**Response to a Request for Further  
Information Summary Report**

**Prepared in Respect of a Proposed  
Residential Development in the Aderrig  
Development Area (Phase 3) of the  
Adamstown SDZ**

**Reg. Ref. SDZ22A/0014**

**Prepared on Behalf of Quintain  
Developments Ireland Limited**

Figure 2.3: Height permitted by the Planning Scheme and those proposed during the latest Phase 4 pre-planning consulting meeting

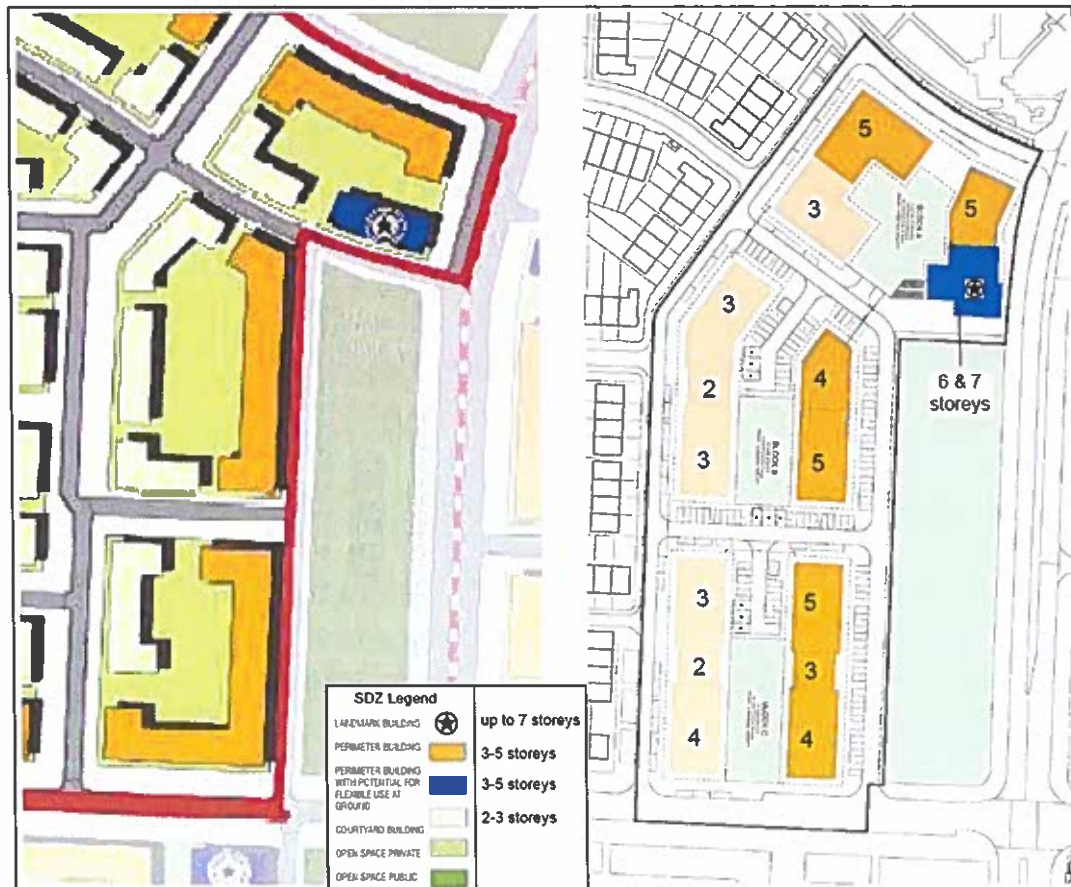
RFI Item 1 principally related to net development area, density and unit mix, cognisant of the future fourth phase of development at Aderrig, seeking:

In terms of height for the Phase 4 development, we refer to Figure 2.3 (extracted from BKD’s *Request for Further Information Response Document*) which demonstrates compliance. The future Phase 4 Planning Application will illustrate that proposal with the various requirements of the Planning Scheme.

Figure 2.5: Revised design at and around the local park, with the car parking along its western and southern edges now omitted

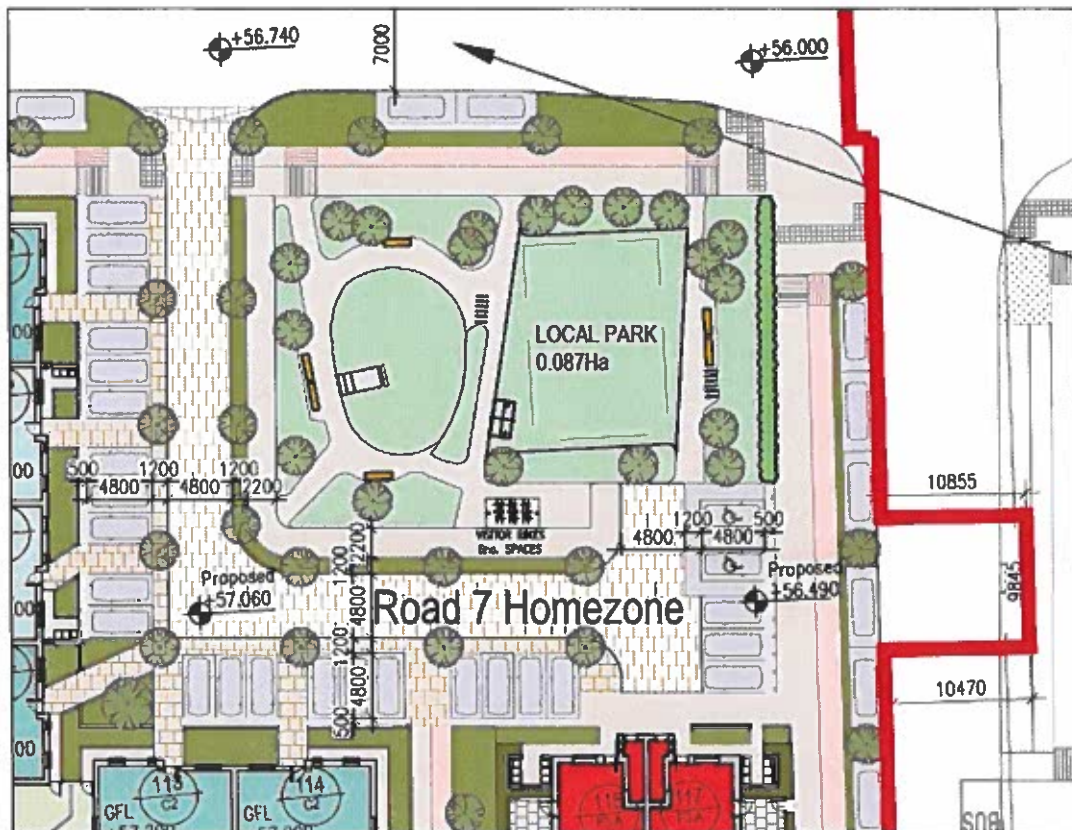
*"It is noted that car parking is provided around the open space to the south east. The applicant is requested to remove the car parking to the south and west of this park."*

As requested, the car parking to the west and south of the local park has been removed. This is demonstrated on BKD's site drawings (*Site Layout Plan* and *Site Block Plan Sheet 2 of 2* drawings (Nos. 6259A-P-003 and 6259A-P-011)) and DOT's landscape drawings (*Landscape Plan 02* (No. LP-02-FI), the latter of which is included in Figure 2.5).

Figure 2.6: Minimum 6m distance to the rear of perpendicular car parking spaces, as proposed in 'Road 2 Homezone'

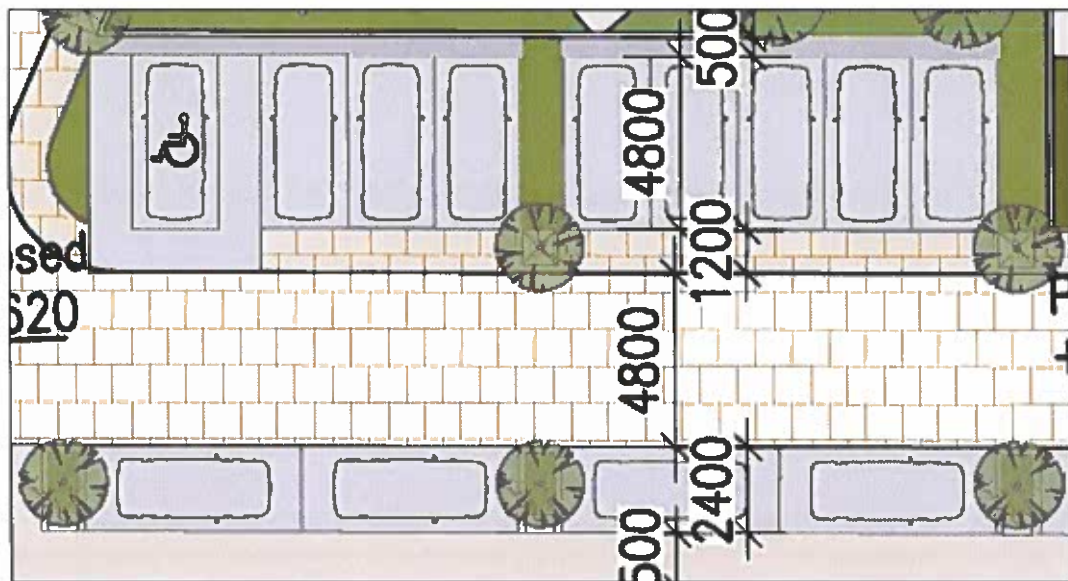
*"The applicant is requested to submit a revised layout showing perpendicular parking only being provided on one side of the street at any point. The applicant should also demonstrate a minimum distance of 6m behind each perpendicular parking space."*

As is evident on BKD's site plan drawings, a minimum of 6m is achieved to the rear of perpendicular parking spaces. Please see the extracts provided in Figures 2.6–2.8 as examples below.
